## EC64-07/08, Part II

IRC R202 (New), N1102.4.2 (New), Table N1102.4.2 (New), N1102.4.3 (New), N1103.6 (New)

**Proponent:** Craig Conner, Building Quality, representing himself

**Note: Condensation occurs above the lines for each product type**

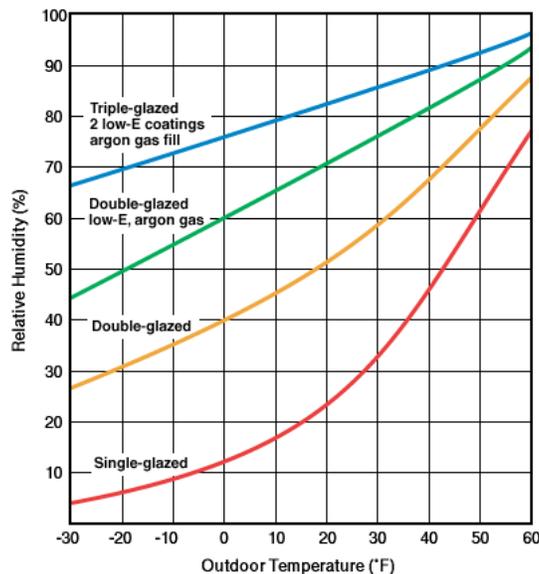
- Improved Condensation Resistance.** Window condensation and the associated problems are a function of the window’s U-factor, the indoor relative humidity, and the outside temperature. Glass with a lower U-factor maintains a higher room-side temperature, which means the glass can withstand lower exterior temperatures and more interior humidity without attracting condensation. Glass with a high U-factor will succumb to condensation much more easily. The following chart also provided by LBNL on the EWC website shows the condensation potential for different window types.

According to the chart, a typical double-glazed low-e window can withstand a 0 degree outdoor temperature and 60% relative humidity inside before condensation will begin to collect. By contrast, a regular double-glazed window can only withstand 40% humidity at the same outdoor temperature. In other words, a low-e window has a 50% more effective ability to resist condensation. A single-glazed low e window is far worse – it can withstand less than 15% humidity at the same temperature – a virtual guarantee of damaging condensation. The fenestration maximums substantially reduce the likelihood of condensation in the colder months, enhancing durability and long-term benefits for the homeowner.

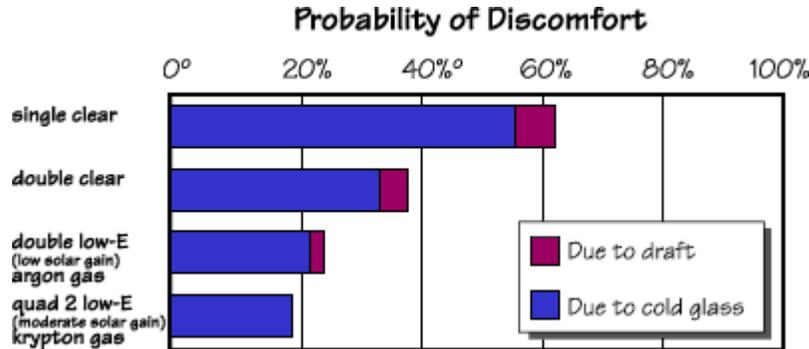
**3. More Comfortable Homes and Less Energy Use.** The energy code revolves around occupant comfort -- any perceived energy savings will be instantly lost if an occupant is uncomfortable and adjusts the thermostat. Incremental changes in window efficiency can have a disproportionate impact on occupant comfort because even the most efficient windows are, at best, still only the equivalent of an R-3 wall. Hot spots created by high solar gain in the summer and cold or drafty glass in the winter months can force an occupant to adjust the thermostat to compensate (which will increase cooling and heating bills at a time when natural gas costs about \$1.20 per therm on the wholesale market and heating oil costs over \$3.60 per gallon wholesale). The charts below, again produced by LBNL and displayed on the EWC website, show that occupant discomfort can double or triple, depending on the type of glass installed.

For example, the following chart shows the probability of discomfort during winter from poorer windows ranging from over 60% with single clear and almost 40% with double clear. This risk declines to almost 20% with a low-e window as specified by Section 402.6. This problem is due to the cold window -- at zero degrees outdoors, the single pane glass is less than 20 degrees on the inside surface, the double clear glass is slightly over 40 degrees, while the low e glass is approaching 60 degrees. Obviously, the warmer the interior glass surface, the less likelihood of discomfort.

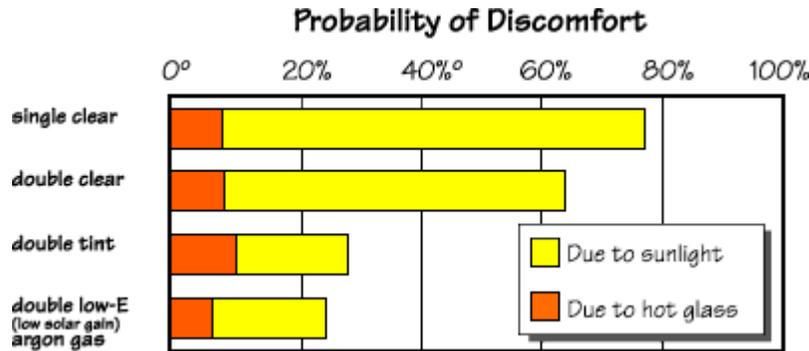
Similarly, the following chart shows the probability of discomfort during summer from sunlight and hot glass. The potential comfort problem from bad windows is even worse in the summer. The summertime probability of discomfort ranges from almost 80% with single clear and over 60% with double clear declining to almost 20% with windows as specified by Section 402.6.

In heating-dominated climates, a good low-e window will keep occupants more comfortable during the coldest months. In cooling-dominated climates, windows with low SHGC will protect against hot spots and occupant discomfort, and will make it less likely that occupants will need to adjust the thermostat and use more energy.

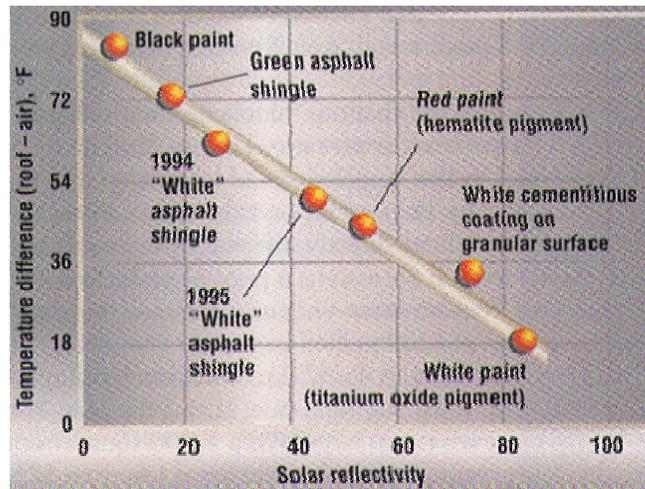
Potential net energy savings from changing roof reflectivity. Savings are measured in dollars. The net savings are the savings of cooling energy use less the penalties of heating energy use.

The Heat Island Group has monitored buildings in Sacramento with lightly colored, more reflective roofs and found that these buildings used up to 40% less energy for cooling than buildings with darker roofs. The [Florida Solar Energy Center](#) performed a similar study, also showing up to 40% cooling energy savings.

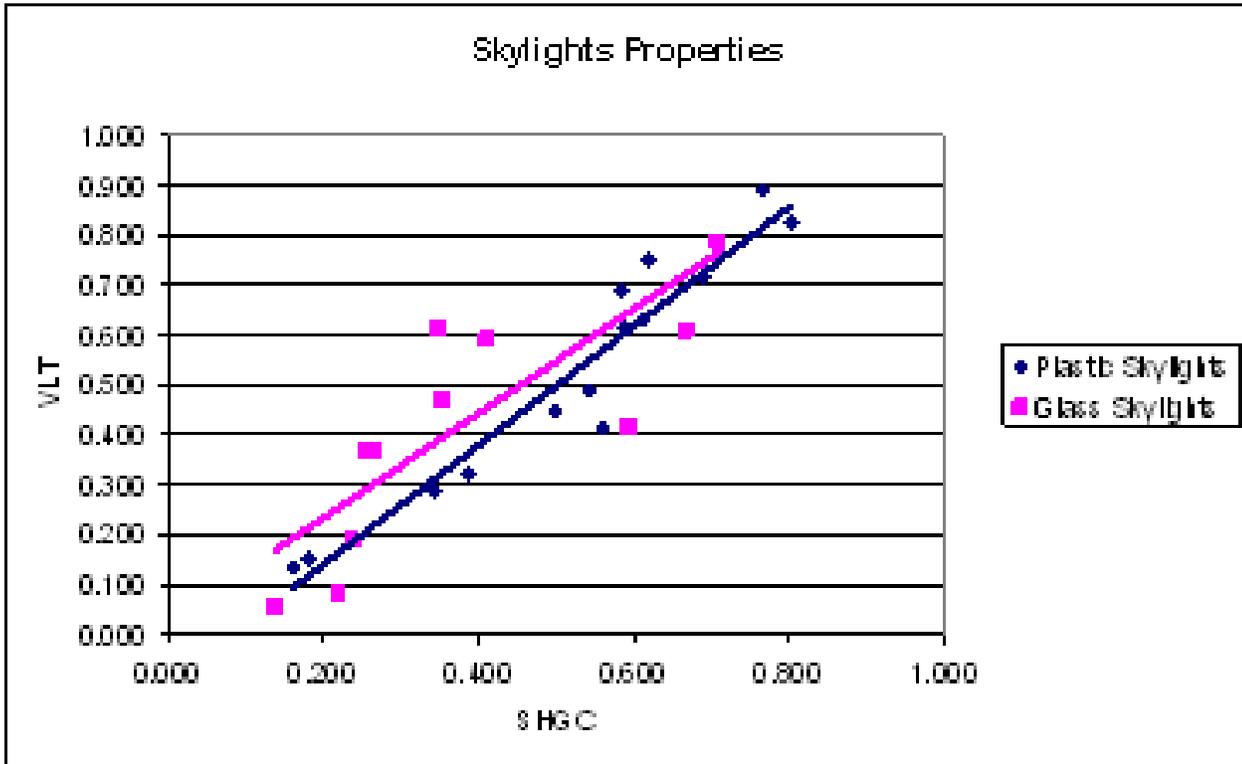
**Commenter's Reason:** This public comment to EC122 would provide significant energy savings over the 2006 IECC for large open spaces in educational, factory, mercantile and storage occupancies by requiring a minimum floor area to be daylight, with automatic lighting controls that reduce the lighting power draw in response to the daylighting that is provided, and permitting the use of skylights that contribute appropriately to the overall amount of daylighting provided. Analysis by Carli, Inc, and the Heschong Mahone Group that was provided to the IECC committee in previous cycles demonstrated that energy savings as great as 40% over the 2006 IECC could be achieved when skylights with both higher U-factors and SHGC are installed in 6% of the roof area in a space with 12 foot high ceilings, in combination with automatic lighting controls, in comparison to the installation of skylights that met the more stringent criteria of the 2007 Supplement to the 2006 IECC for both U-factor and SHGC, at 3% of the roof area, without automatic lighting controls. (Background information is available at <http://www.fenestration.com/skylights.php>). A proposal based on the same analysis has been approved for the next edition of ASHRAE 90.1.
